PACSB / XL / 094 ISSUE 2

SERVICE

# PITOT-STATIC SYSTEM – PITOT-STATIC TUBES SUPPORT CLAMP

FIGURE 1 PITOT-STATIC SYSTEM – PITOT-STATIC LINES AND FLAME ARRESTOR INTERSECTION

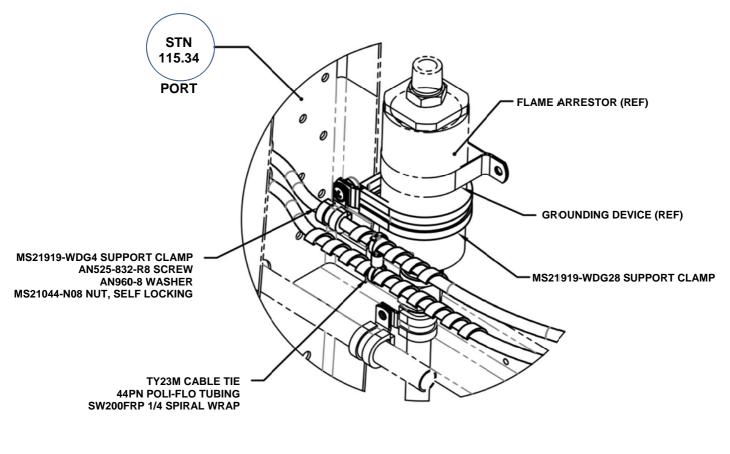
- A. <u>EFFECTIVITY</u> PAL 750XL aircraft up to and including S/N 220.
  - REASONProduction Inspection of installed Pitot-Static<br/>plumbing, identified a potential hazard.<br/>Insufficient clearance between pitot plumbing and<br/>primary support at flame arrestor intersection,<br/>could result in chafing of the pitot tube.

- C. <u>DESCRIPTION</u> Install an additional support clamp for Pitot-Static tube support (located next to port flame arrestor), protect plumbing with spiralwrap and fix pitot and static tubes separation to protect pitot-static plumbing from possible chafing.

- 1) Remove the cabin lining at STN 115.34 to access area of the flame arrestor.
- 2) Inspect the pitot static tubing for damage adjacent to the flame arrestor. If damage is found, repair or replace the tubing and carry out a pitot & static leak check.
- 3) Install pitot-static lines supporting clamps as shown in Figure 1. Use alternative way shown in Figure 2 if pitot-static lines traced between the flame arrestor and fuselage skin.
- 4) Ensure clamps supporting pitot-static lines are located as depicted to prevent low points from forming.
- 5) Protect Pitot-Static plumbing with spiral wrap. Use either existing or additional spiral wrap as required.
- 6) Fix pitot and static tubes separatly using cable tie and 8mm-length poli-flo tube as spacer.
- 7) Re-install the cabin lining at STN 115.34.
